IN THE SPECIFICATION

REMARKS

Claims 86-107, 109-123, 125 and 126 are pending in this application.

FIG. 11

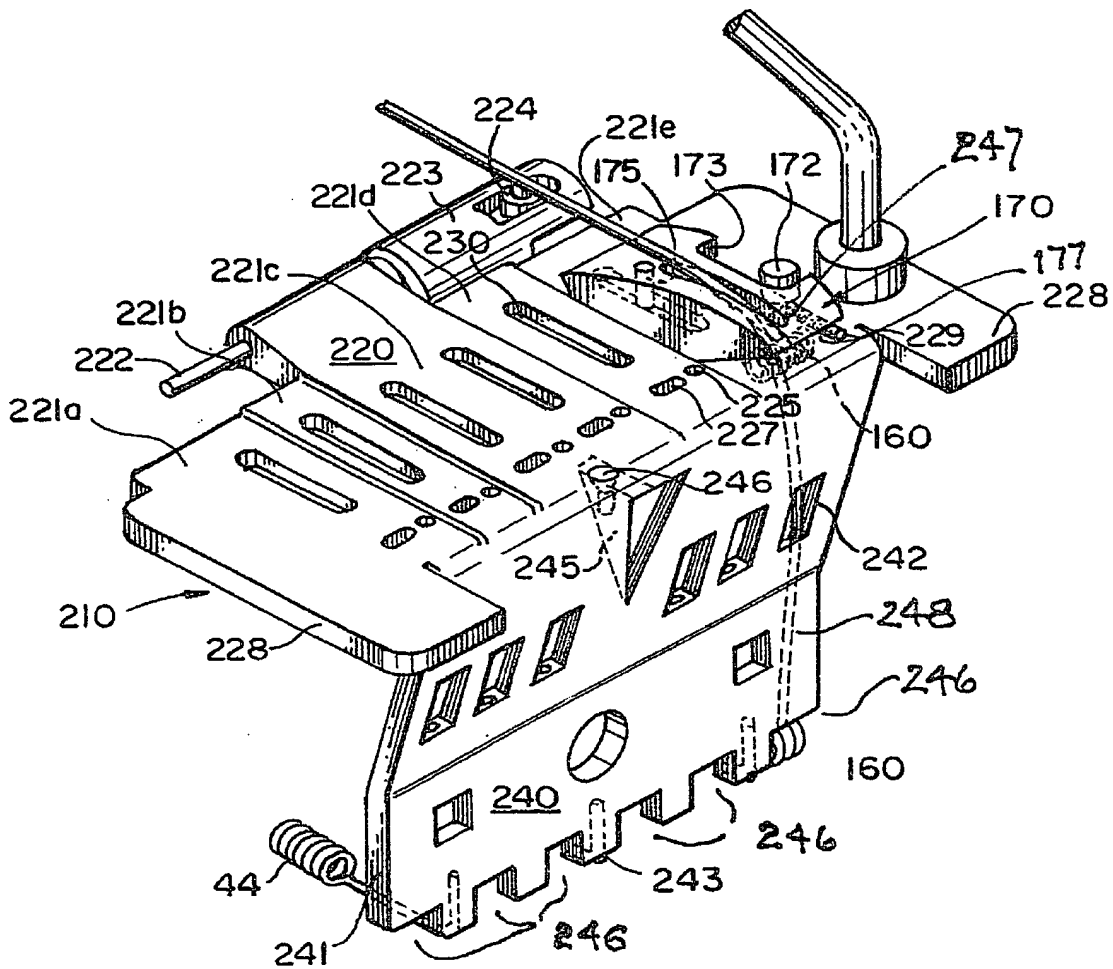
Figure 11. is amended to include:

- number 177, the rearward portion of intonation module 170, previously presented in phantom only;
- number 246 to denote string anchoring points on the lower portion 140 of spring block or spring blade 240 for receiving anchoring ball 160;
- number 247 to indicate the alternate string anchoring point for receiving anchoring ball 160 on the rearward portion 177 of 170;
- number 248 to indicate the “elongated cylindrical passageway” in the string blade or spring block.
